SERVICE BULLETIN

Change of measurement method from cylinder head temperature to coolant temperature for ROTAX® Engine Type 912 and 914 (Series)

ATA System: 75-00-00 Cool system

MANDATORY

Fig. 1

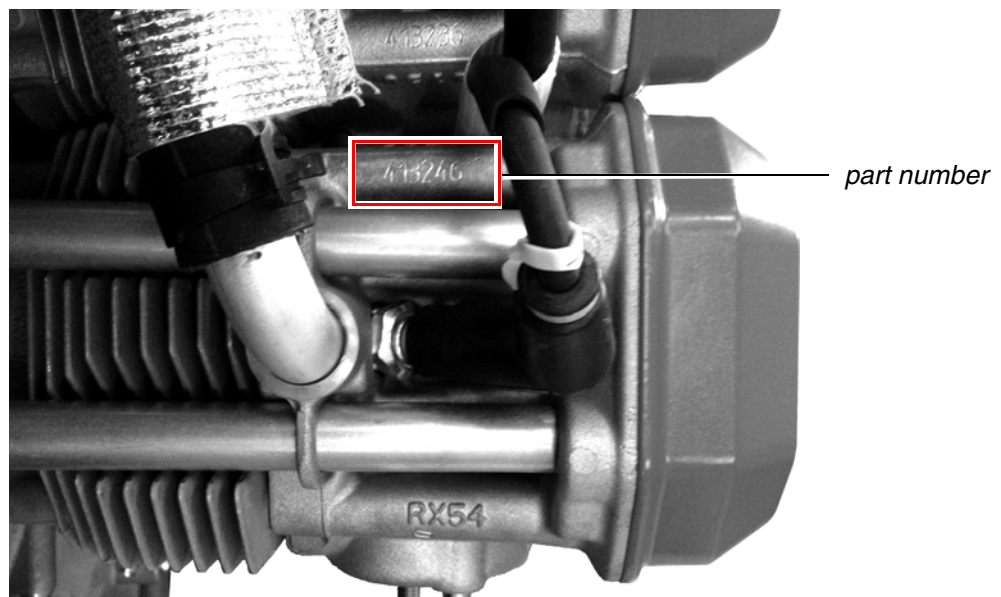
Step	Procedure
1	Check the engine serial number S/N, if the aircraft is affected by this SB.
2	Check of maintenance documentation if a repair or maintenance was performed on one of the cylinder heads.
3	Check the part numbers of the cylinder heads. See Fig. 1.
4	Check of the cockpit (indicating instruments) or the aircraft-specific manuals or consultation with the aircraft manufacturer or its service facilities if the coolant temperature or cylinder head temperature is displayed.
5	The measurement position naming in the indicating instrument or the operating limit must be amended or corrected in consultation with the aircraft manufacturer, if necessary. See section 3.1.1)

Fig. 2

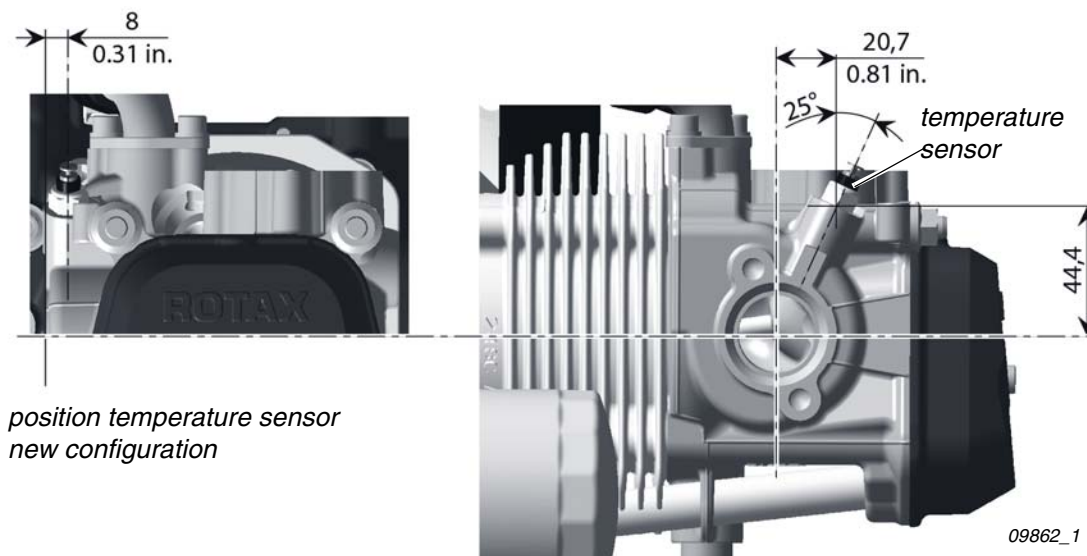
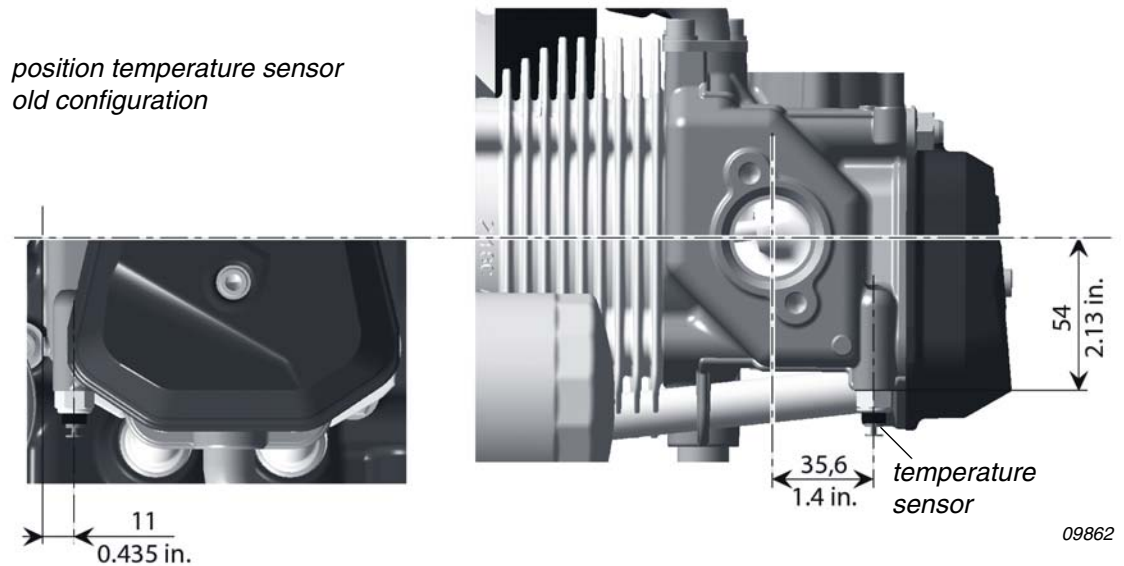
NOTE: Identifying of new cylinder heads: The electrical connection of the temperature sensor is pointing upwards. New configuration see [Fig. 2](#). Old configuration see [Fig. 3](#).

Regarding change of temperature sensor position, see Fig. 2 and Fig. 3.

NOTE:

It is NOT mandatory to retrofit engines with the old cylinder heads. The different versions of the cylinder heads can be mixed installed, but make sure, if and at which position the cylinder head temperature and coolant temperature is measured. This also defines the naming of the indicating instrument with the appropriate temperature limit.

Coolant temperature limit for measuring point in the cylinder head (new configuration)	Engine type
maximum 120 °C (248 °F)	912 A/F/S
	914 F
Permanent monitoring of coolant temperature is necessary
